MACHINE SERVICE BULLETIN #112

SUBJECT: Lock for Clear-out Mechanism "C" and "E" Models

DATE: March 6, 1931

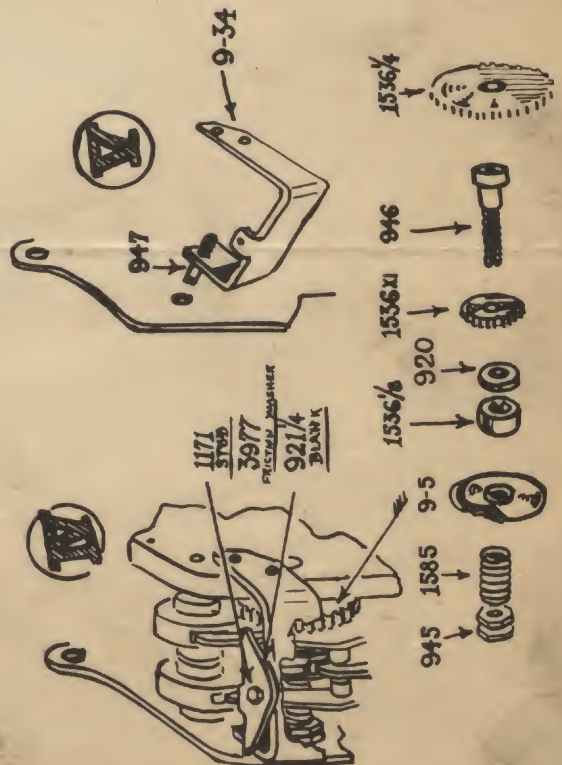
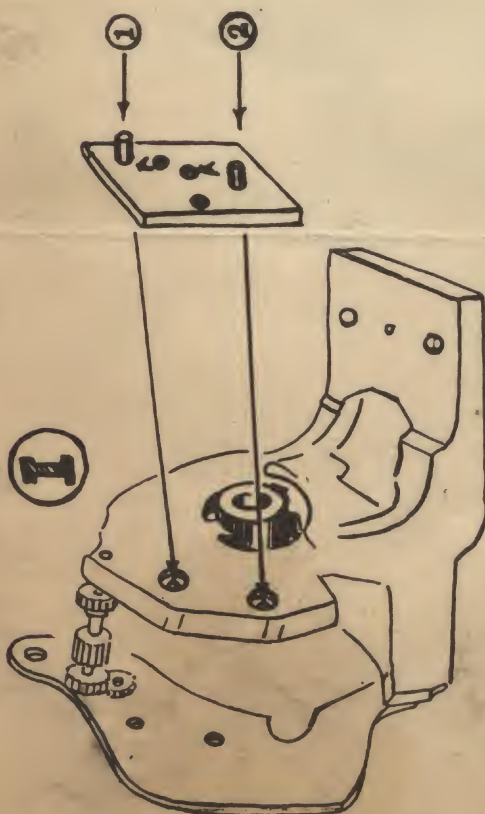
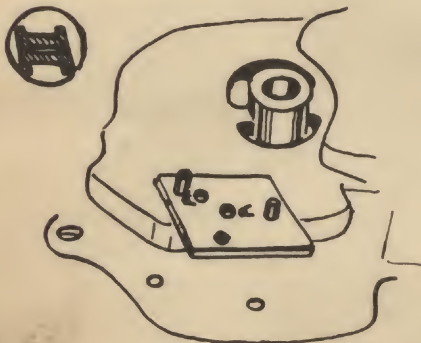
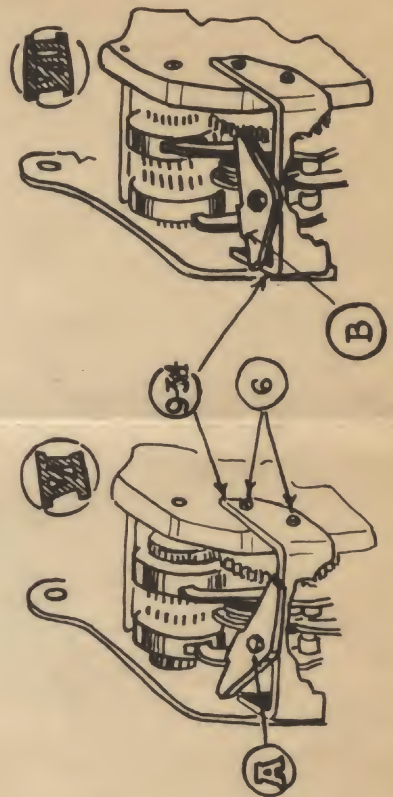
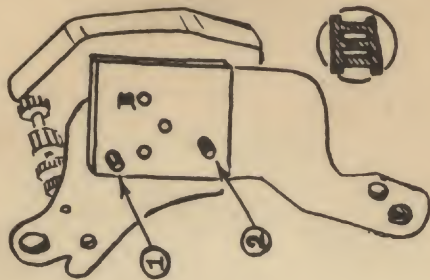
Place the drill jig on the motor bracket with the side of the jig marked A, out. Pins 1 and 2 of the jig should be located in the holes in the motor bracket as shown in figure 1 of the attached sketch. Drill holes A, through the motor bracket with a #32 drill. If the drill starts to chatter after the holes are started, remove the jig and complete the drilling without the jig, and thread these holes with a #6-40 tap.

Next, drill one hole in plate 1520 as shown in figure 3, with the side of the jig marked B, out, and with pins 1 and 2 of the jig located in the holes in the plate corresponding to the same holes in the motor bracket. This hole, B, should also be drilled with a #32 drill, but it is not to be tapped.

Replace parts C, D, E and F, plate 18, in their original position. In place of the original parts that were assembled on the lower 1552 shaft, parts shown in figure 4, are to be used. These are to be assembled as follows: First, the gear, 1536x1, goes over the left end of the 946 shaft with the smooth side of the gear away from the shoulder of the 946. Next, the fibre washer, 920, is assembled; then the collar, 1536-1/8, with the smooth side next to the fibre washer; then the clutch drum G, plate 18, which was removed from the bracket; then the spring, 1585, and the two lock nuts, 945. Assemble gear 1536 $\frac{1}{4}$ on the right end

Screw the 947 screw into the tapped hole in the left-hand end of the lock assembly, 9-34. This screw goes into the hole which was drilled in the 1520 plate. The bracket is fastened to the casting, with two #6 screws, into the holes that were drilled and tapped. (See figure 6). If a variation in the casting should cause a clearance between the casting and the assembly, 9-34, when the left end of the 9-34 is up against the 1520 plate, it will be necessary to pack thin washers between the 9-34 and the casting to take up this space before tightening screws #6. This is necessary to prevent the 9-34 from being sprung. However, if the variation is the other way, so that when the 9-34 is screwed tight against the casting, and the left-hand end is not tight against the plate, this can be taken care of by adjusting the eccentric stud, 1171, as 947 is long enough to act as a dowel.

The new lock functions in such a way that when either of the noses for clearing the upper or the lower dials is out, the other one is locked in. Stud A, figure 6, is an eccentric for adjustment. Figure 6 shows the position of the lock with the nose for clearing the lower dials out. Figure 7 shows the position of the lock with the nose for clearing the upper dials out. The lock should be adjusted so that when the upper dial nose is out, it rides up onto the high spot on the lock as shown. Also, when either nose is out, the locking piece should have a slight play. This may be tested by depressing each of the clear keys in turn and turning the driving lug on the end of the sun gear in a counter-clockwise direction, until the nose has released the clutch drums and the clutch drums have started to rotate. NOTE: If there is not enough movement in the eccentric adjustment "A" to take up any excessive play that may exist between the lock and the nose which is engaged, it will be necessary to adjust the nose which is not engaged farther away from the drum, as explained on Plate 22 of Machine Service Bulletin #108.

When the nose for the upper dial clutch comes out and starts to ride up on the high part of the locking piece, if it should catch, stone the corner slightly more round at point B, figure 7.
